ENGINEERING CHANGE NOTICE

1. ECN 634619

5. Project Title/No./Work Order No. Groundwater Monitoring Plan for the Solid Waste Landfill, Hanford, Washington	6. Bldg./Sys./Fac. No. SWL	7. Impact Level QE

8. Document Numbers Changed by this ECN (includes sheet no. and rev.) WHC-SD-EN-AP-043, Rev. 0	9. Related ECN No(s). N/A	10. Related PO No. N/A
11a. Modification Work <input type="checkbox"/> Yes (fill out Blk. 11b) <input checked="" type="checkbox"/> No (NA Blks. 11b, 11c, 11d)	11b. Work Package No. N/A	11c. Modification Work Complete N/A _____ Cog. Engineer Signature & Date	11d. Restored to Original Condition (Temp. or Standby ECN only) N/A _____ Cog. Engineer Signature & Date

Figure 3-1. Location Map Showing Proposed New Monitoring Wells.

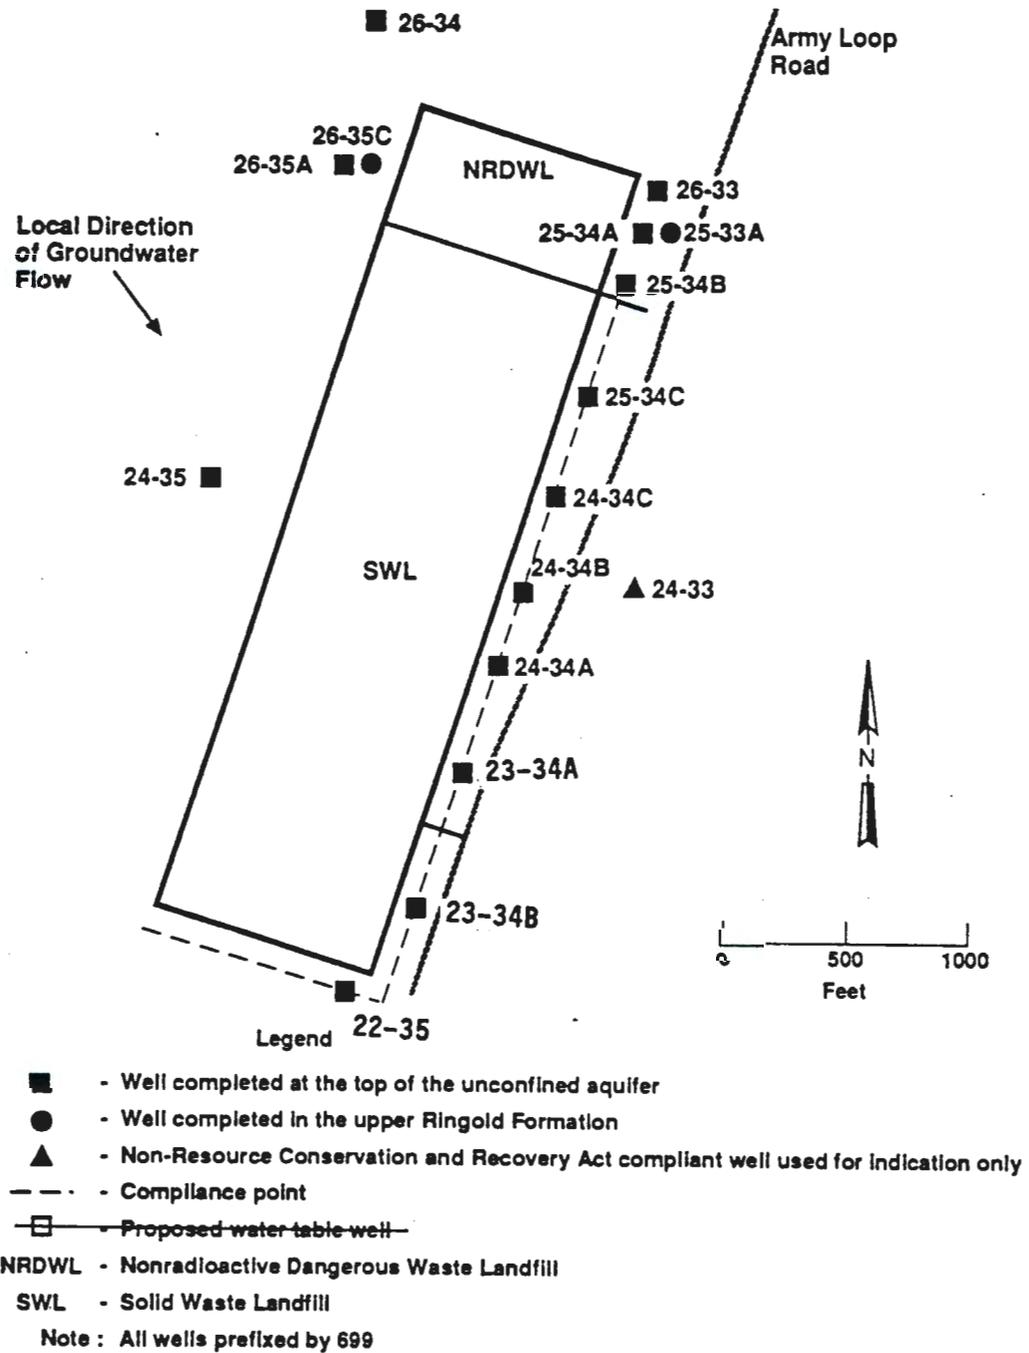
Two new compliance point wells have been installed to assess and improve the groundwater monitoring system around the SWL. These wells will provide information to help characterize the shallow hydrogeology at the landfill and determine the quality of groundwater near the top of the unconfined aquifer.

Two new wells ~~have been~~ added to the existing monitoring system at the SWL. The new wells ~~are~~ downgradient, compliance point wells that will complete the shallow compliance point coverage around the south end of the site. ~~The two additional monitoring wells will be completed in the top 10.7 to 15.2 m (35 to 50 ft) of the unconfined aquifer. Estimated coordinates and construction details for these wells are presented in Table 3-2 and shown in Figure 3-1.~~
